**Memorandum**  
**Date:** May 5, 2011  
**To:** Bill Springer, RK&K  
**From:** Bob Denton, GeoConcepts Engineering, Inc.  
**Subject:** Regulatory Summary Memo - Maintenance Facility Fuel Island Improvements (Our 11003)

**Subject: Notice of Planned Change - Leesburg Central Maintenance Facility Fuel Island**

FUEL ISLAND UPGRADE

CORRESPONDENCE

**ATTACHMENT A**  
**EXISTING CONDITIONS**

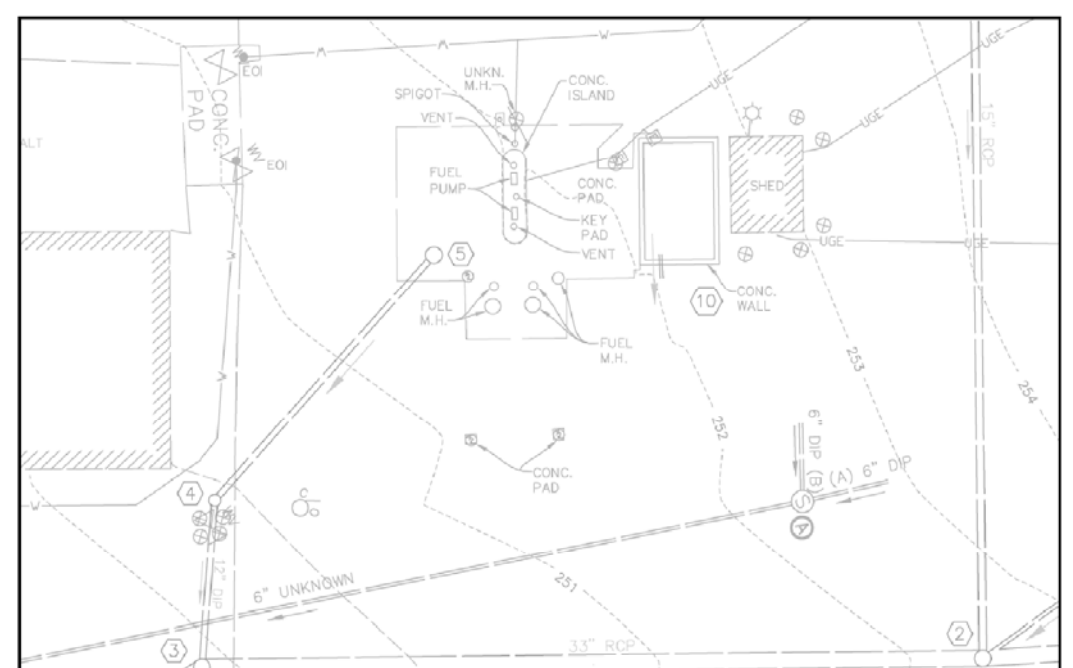
Based on the need to upgrade aging infrastructure, provide additional fueling capabilities and enhance safety, the Town of Leesburg proposes to upgrade their Central Maintenance Facility's fuel station. This project proposes the removal of two underground fuel storage tanks and replace them with two (2) 6,000 gallon above ground storage tanks. New fuel dispensers will also be installed. Demolition of existing fuel island infrastructure and accessory structures will be required in addition to a removal of the concrete pad, concrete island, tanks, and dispensers. A diagram showing the existing site conditions is included as Attachment A. The existing site is currently drained by overland flow directed towards grate drop inlets which connect to the on-site storm sewer system. The first grate inlet near the existing fuel island contains a valve that can be closed to prevent runoff from entering the storm sewer at this location. The project site drains through the existing storm sewer system into an open ditch, and then into the floodplain of Tuscarora Creek, approximately 220 feet from the existing fuel island.

**ATTACHMENT B**  
**PROPOSED CONDITIONS**

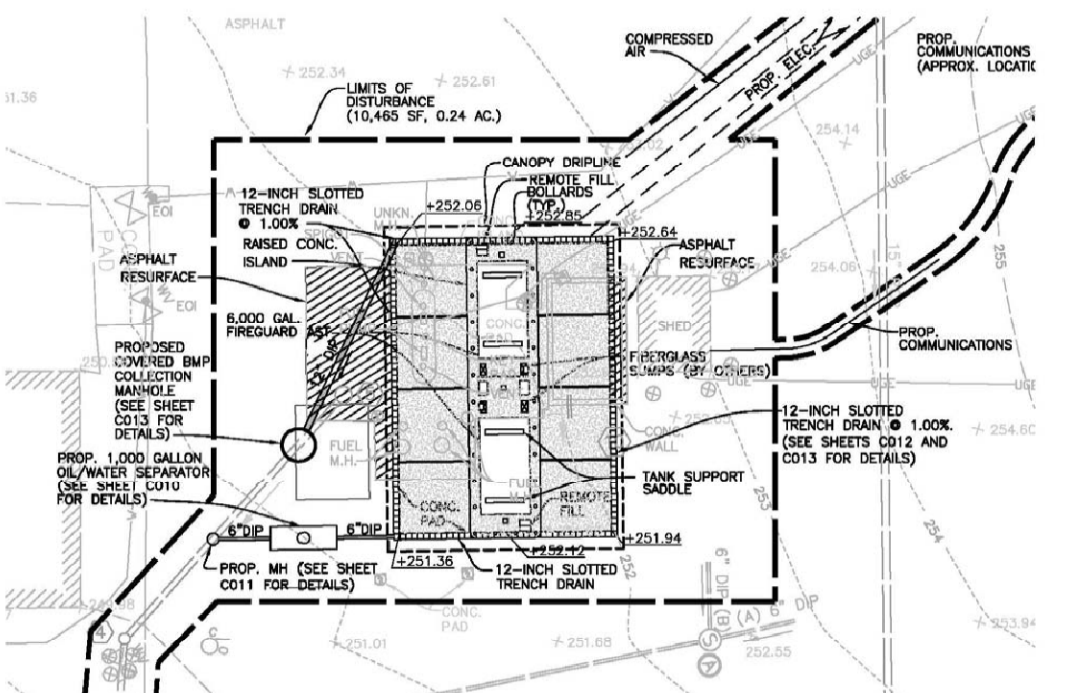
**Canopy:** A new, heavy duty canopy will cover the entire fuel island to minimize the amount of precipitation falling directly onto the new concrete fuel island pad. Lights will be provided to provide additional security.

**Storm Drainage System:** The proposed improvements will be drained by a modified storm drainage system that incorporates variety of new BMPs aimed to enhance water quality and to minimize and contain any potential release of petroleum hydrocarbons. The improvements are summarized as follows:

- **Slotted Trench Drains to new BMP Device:** The concrete island will be surrounded by slotted trench drains to capture surface runoff. On the upstream edge of the concrete fuel island pad, slotted trench drains will intercept surface water from the parking lot and direct the runoff through a small storm sewer to a new underground BMP stormwater management filter system (Context StormFilter) before runoff can flow over the concrete fuel island pad. The BMP device will provide up to 65% removal efficiency for phosphorous and nitrogen runoff. Runoff from the canopy will also be placed directly into the slotted trench drain and storm system and through the BMP device.

- **Slotted Trench Drains to Oil/Water Separator:** The downstream portion of the concrete fuel island pad will capture the limited expected runoff underneath the canopy through slotted trench drains. This runoff will be directed to a new 1,000 gallon capacity oil/water separator that is intended to remove petroleum products for the stormwater runoff stream resulting from routine spills and overfills at the fuel island. The oil/water separator will also function as a back-up containment in the event of a significant spill or release occurring at the fuel island. The oil/water separator will be connected to the existing storm sewer system, just downstream of the proposed BMP device.

- **Storm Sewer Shut-Off Valve:** The existing inlet immediately downstream of the BMP device and oil/water separator contains a valve that can be manually closed to prevent additional water from entering the storm sewer system. This is identified as inlet #4.

Thank you for your correspondence dated May 4, 2011, with respect to the planned improvements at the Town of Leesburg Central Maintenance Facility. DEQ has reviewed the information and has no comments or objections to the project.
